ADDENDUM #2

DATED: JULY 29, 2025

**PROJECT: HUXFORD ELEMENTARY SCHOOL GYMNASIUM AND
CLASSROOM ADDITION FOR
ESCAMBIA COUNTY BOARD OF EDUCATION
HUXFORD, ALABAMA**

PH&J No: 2312SC

LS1.1

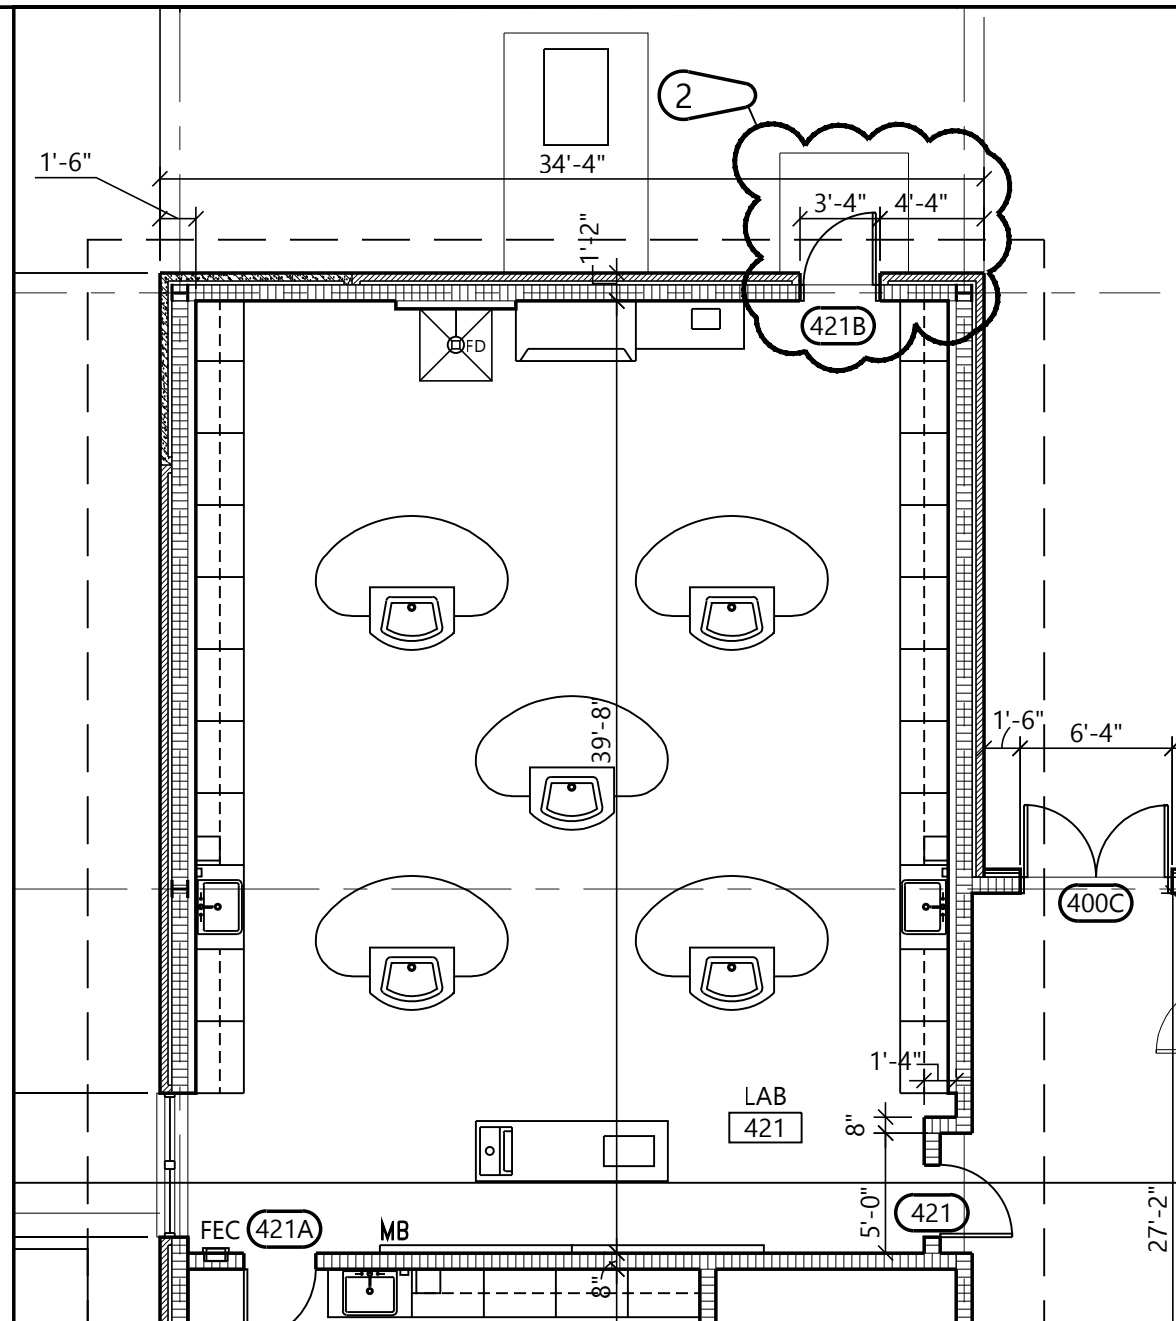
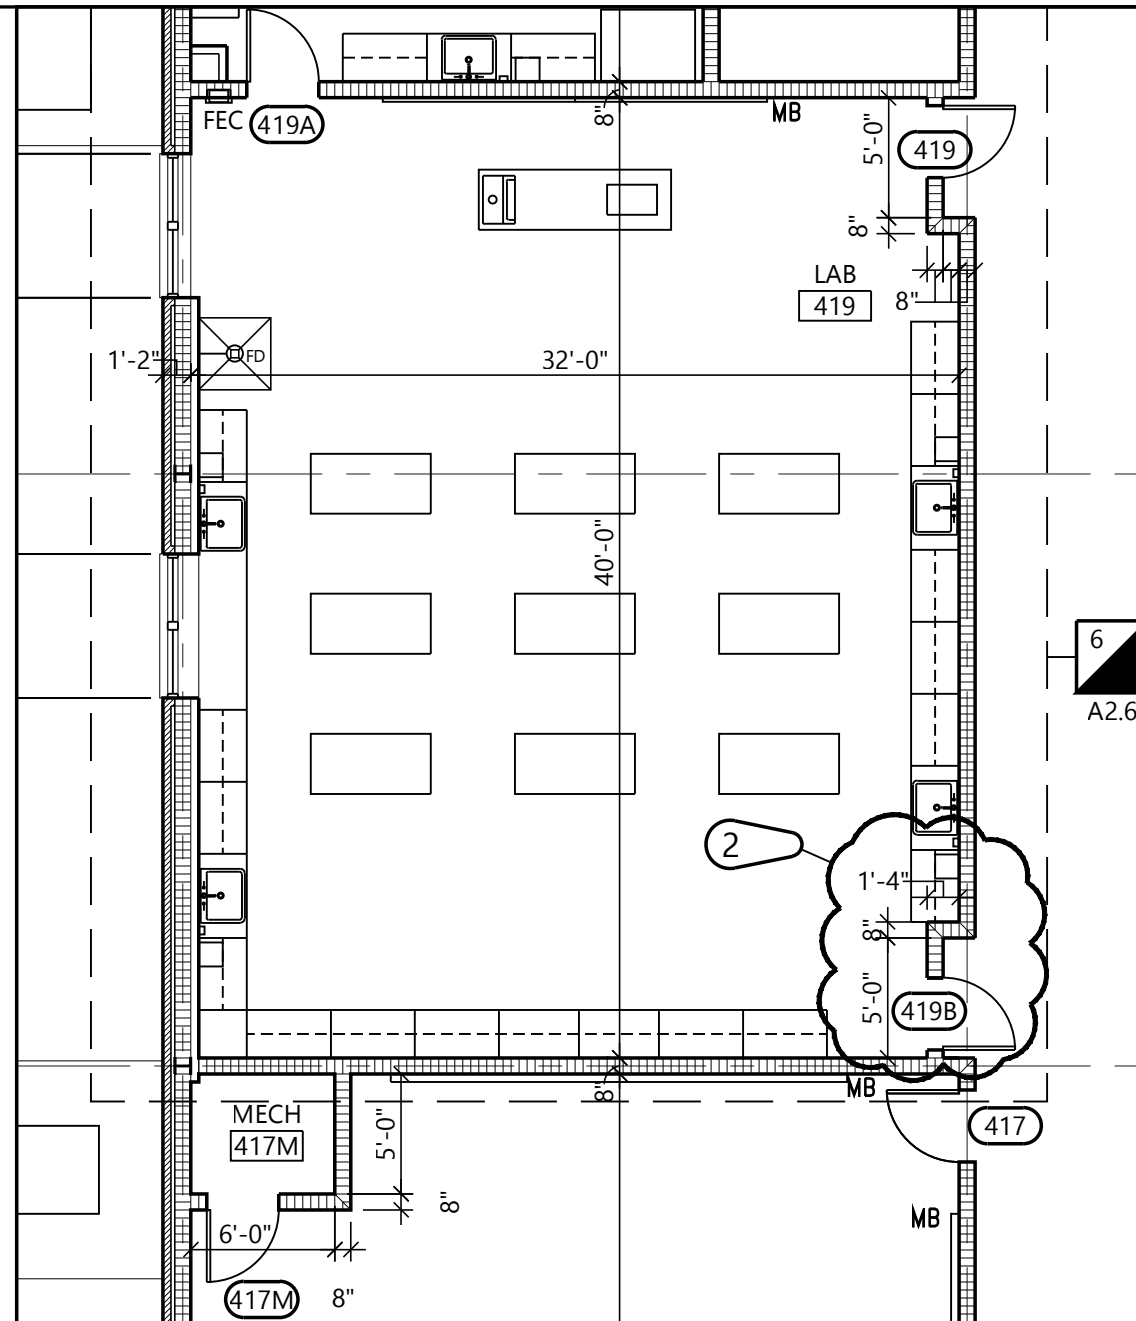
1. **Life Safety Plan (Sheet LS1.1)**: Revision to rooms 419 and 421, Partial plan of LS1.1 is enclosed as **Attachment No. 1**.
2. **Revisions Rooms 419 And 421 (Sheet A2.3)**: Partial floorplan layout of Labs 419 and 421 is enclosed as **Attachment No. 2** for the sheet bound in the Drawings.
